### 95.8.5 Transmitter vertical eye closure (TxVEC)

#### 95.8.5.2 TxVEC measurement method

**Figure 95–4—Illustration of the TxVEC measurement**

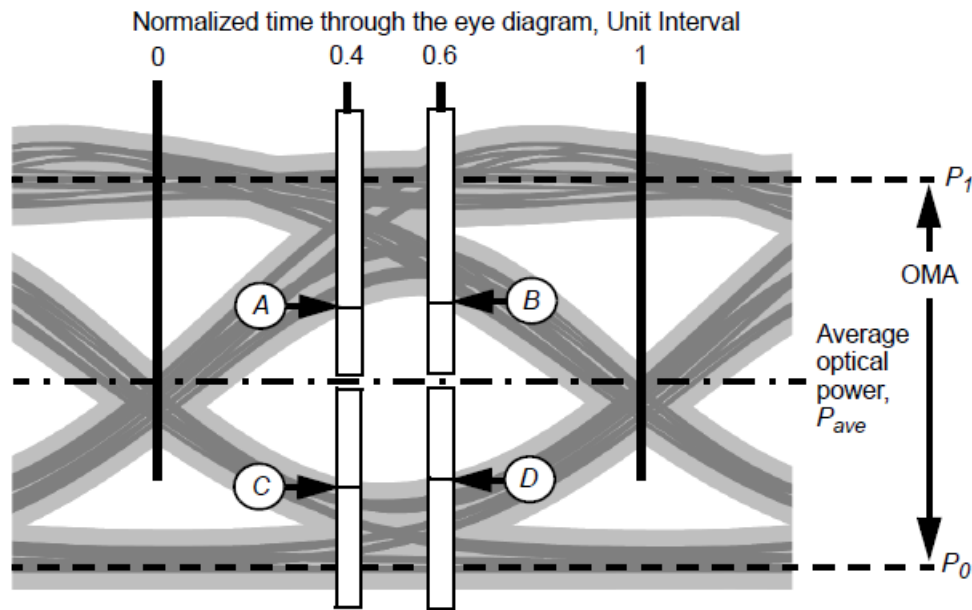
In Figure 95–4, delete the round labels and arrows A, B, C D. The values of P1 and P2 are not used in the calculation; they could be deleted if desired

$P_1$   $P_0$ [PD1] OMA ~~C-D-A-B~~
